# **Explanation of Significant Differences to the Final Record of Decision for Parcel C**

**Hunters Point Shipyard  
San Francisco, California**

**October 2014**

**RESPONSE TO COMMENTS ON  
DRAFT EXPLANATION OF SIGNIFICANT DIFFERENCES TO THE  
FINAL RECORD OF DECISION FOR PARCEL C, HUNTERS POINT NAVAL  
SHIPYARD, SAN FRANCISCO, CALIFORNIA**

**FIGURE 4-12**

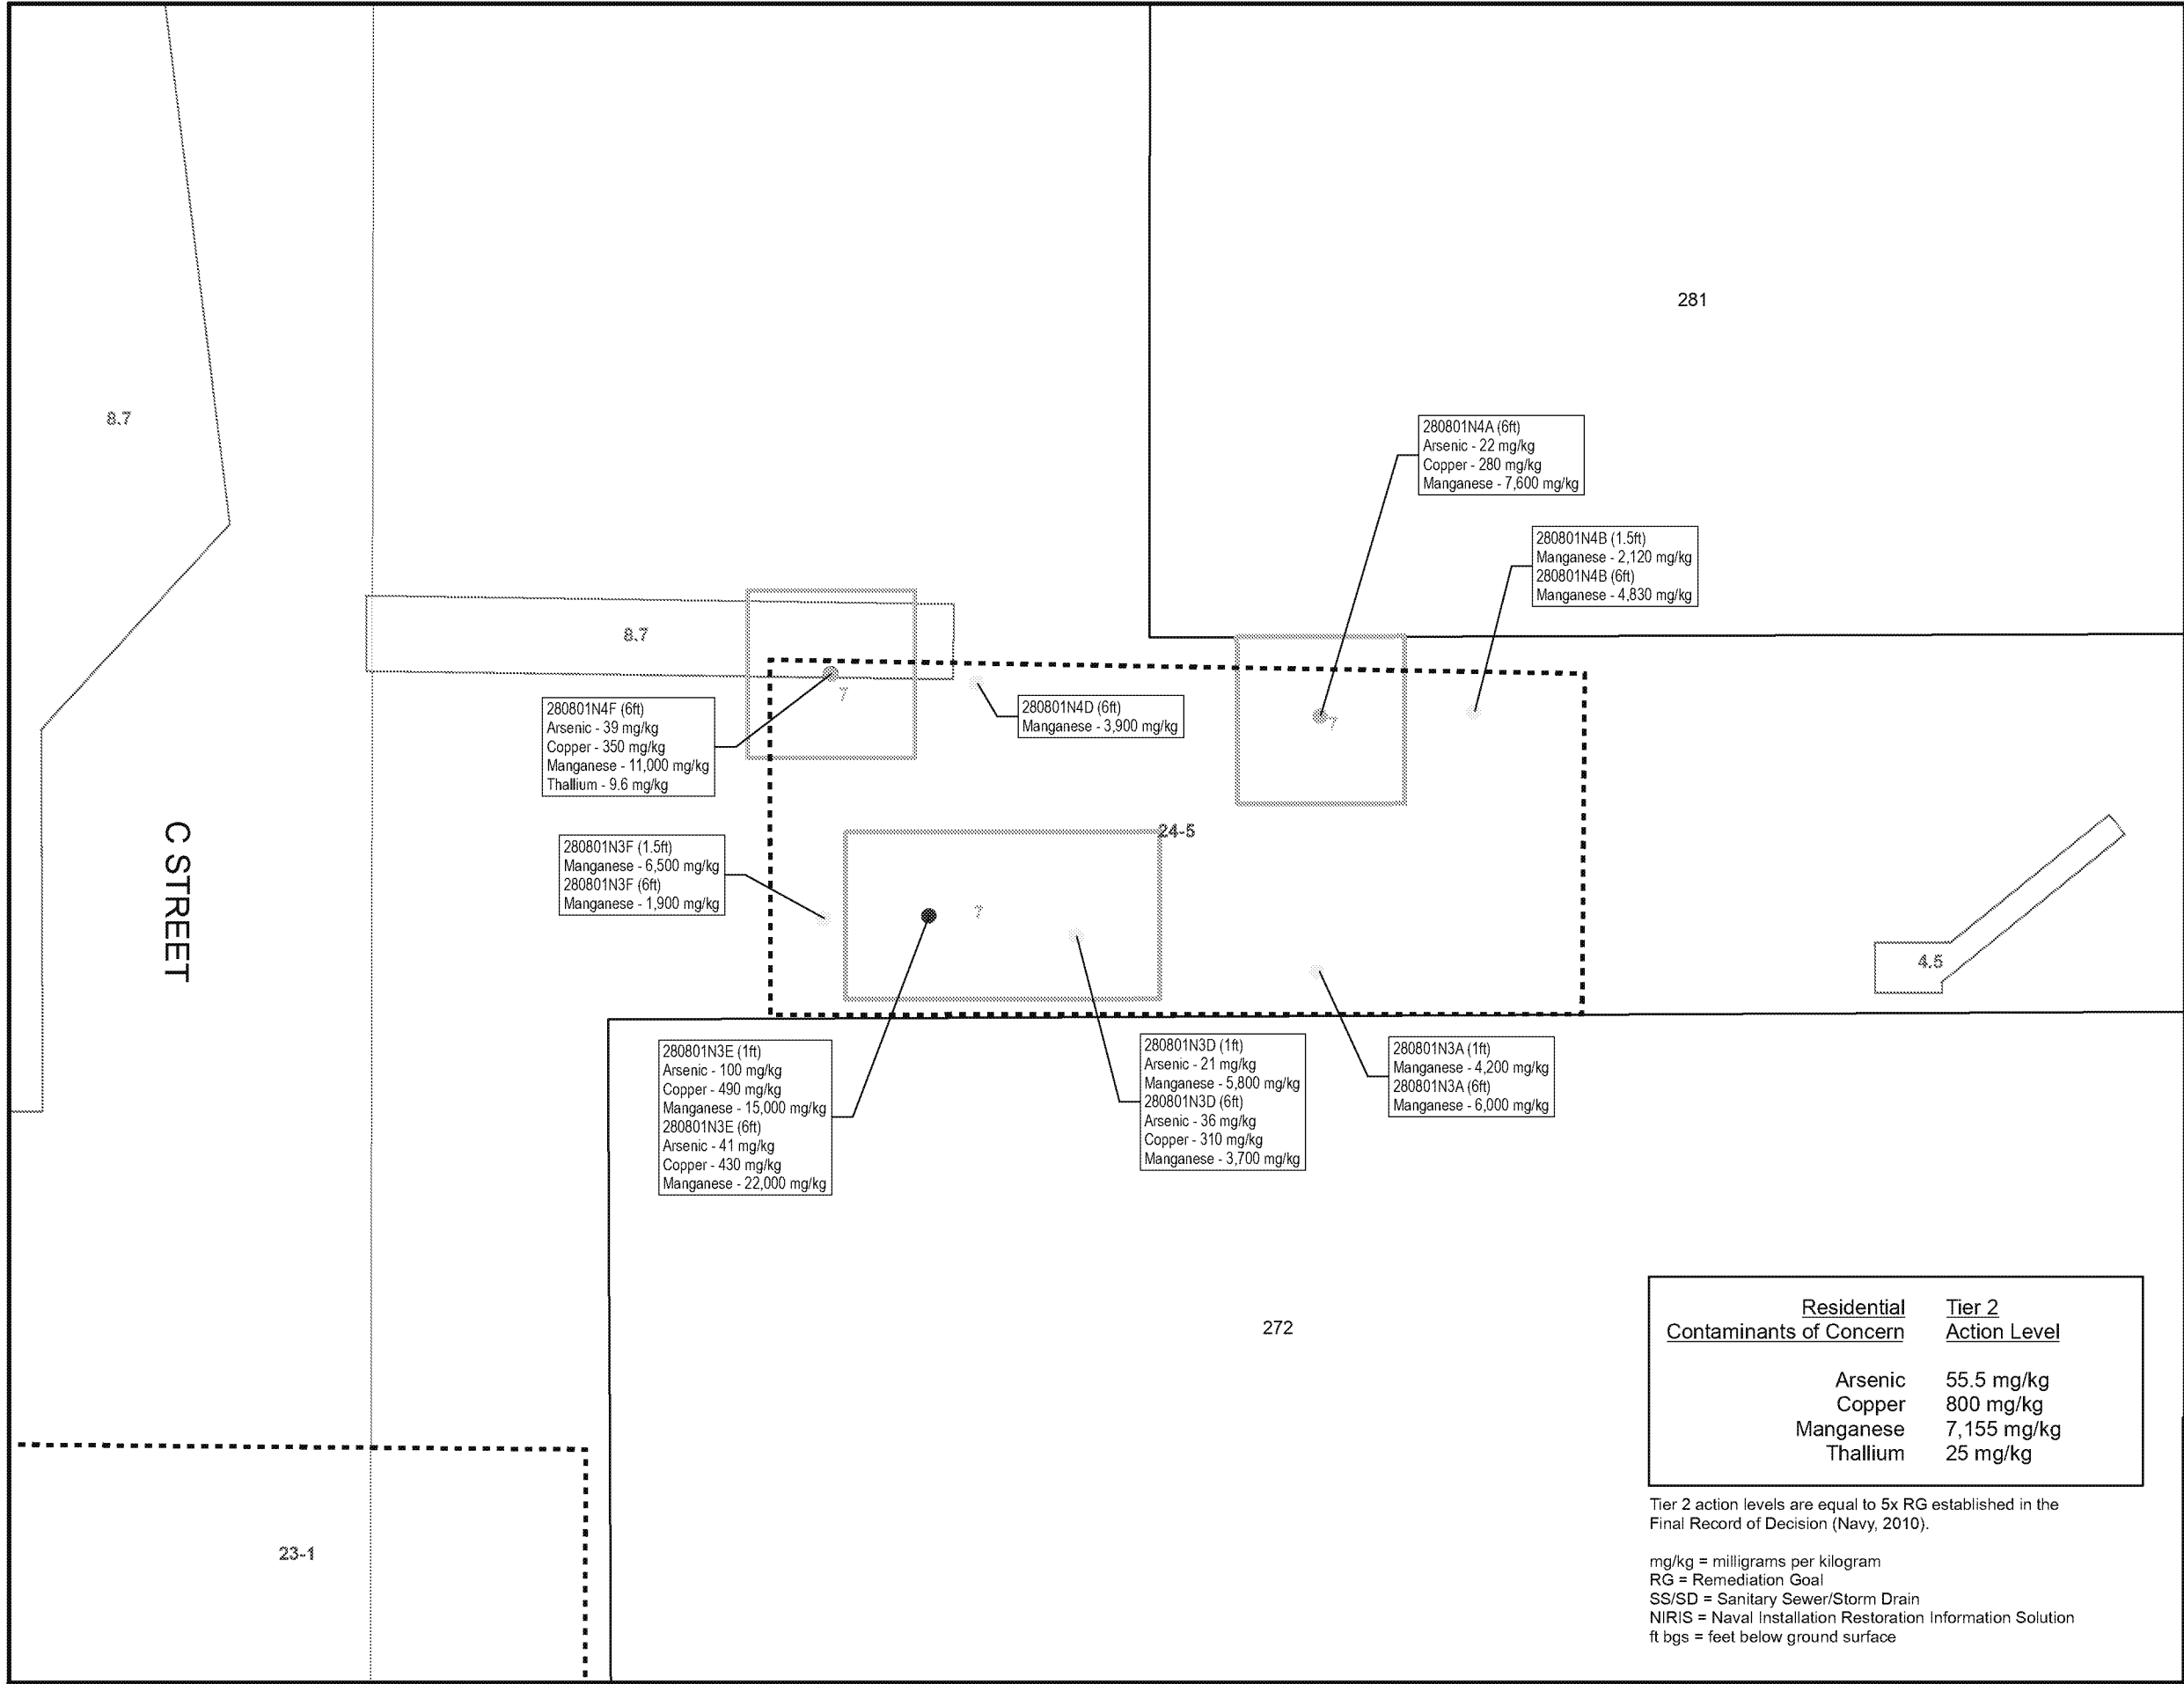
13.	<b>Section 4.2.2 Soil Excavation 24-3</b>	The ESD proposes to remove this excavation area such that no further excavation would take place. However, Figure 4-12 shows PAH concentrations above RGs. Leaving soil with PAH concentrations exceeding RGs is not consistent with the proposed tiered approach. Please revise the text to provide justification for removing this excavation area given then PAH exceedances.	Although residual polycyclic aromatic hydrocarbon (PAHs) are detected at Excavation Area 24-3 at concentrations exceeding RGs, the cumulative residual risk for Excavation Area 24-3 (excluding arsenic and vanadium, for which concentrations are statistically similar to background) does not exceed the risk management range of 1E-04 to 1E-06 and the hazard index (HI) is less than the threshold of 1.  In addition, detections of residual PAHs above the RG were at concentrations slightly exceeding RGs and were limited to one location at area 24-3 (IR28B243, 8.75 feet bgs); residual risks were estimated using residual PAH detections at this location as exposure point concentrations (EPCs), as 95 percent UCL EPC results from USEPA's ProUCL software defaulted to the maximum detected concentration. This approach likely results in an overly conservative estimate of residual risks because it assumes

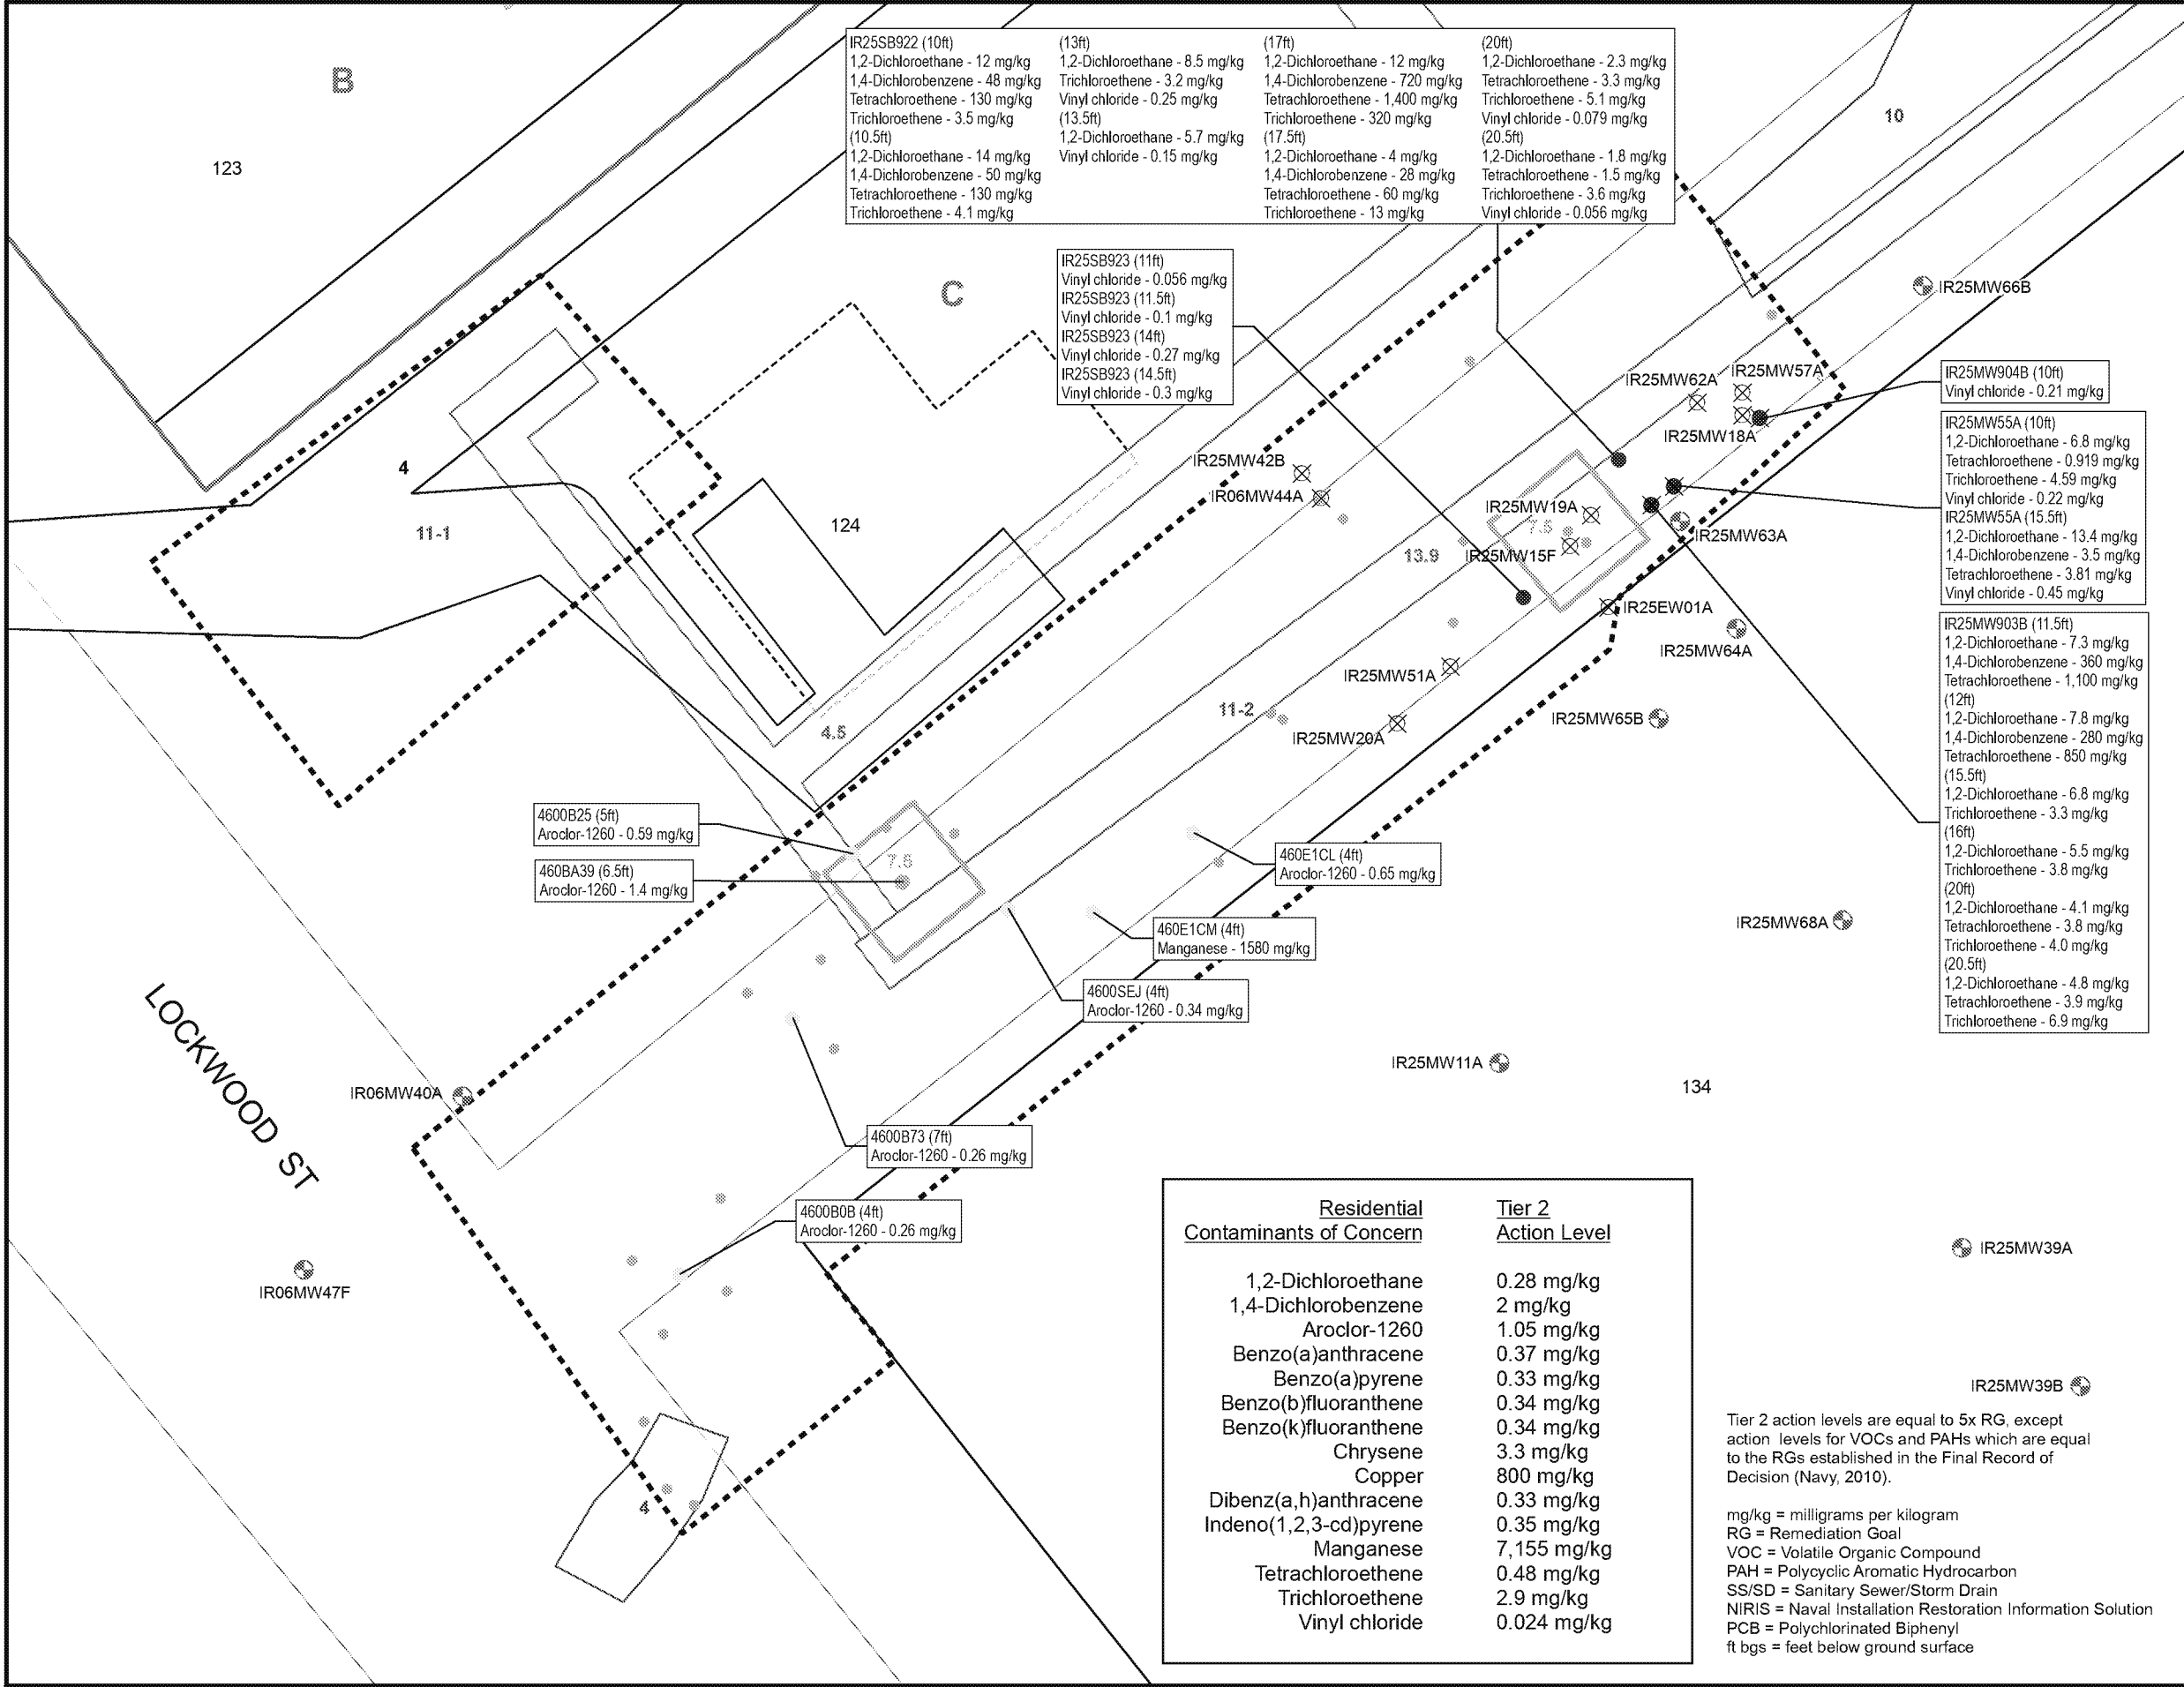
4.	<b>Section 4.2.3 – RU-C5. Soil Excavation 11-2 subsection. Last paragraph.</b>	The text states that a second 10-foot by 10-foot area will be excavated to 3.5 feet below ground surface (bgs), but the corresponding Figure 4-14 has this area labeled as a 7.5 feet bgs excavation. Please correct the text / figure accordingly.	The last sentence of Section 4.2.3 has been edited to say 7.5 feet bgs instead of 3.5 feet bgs.
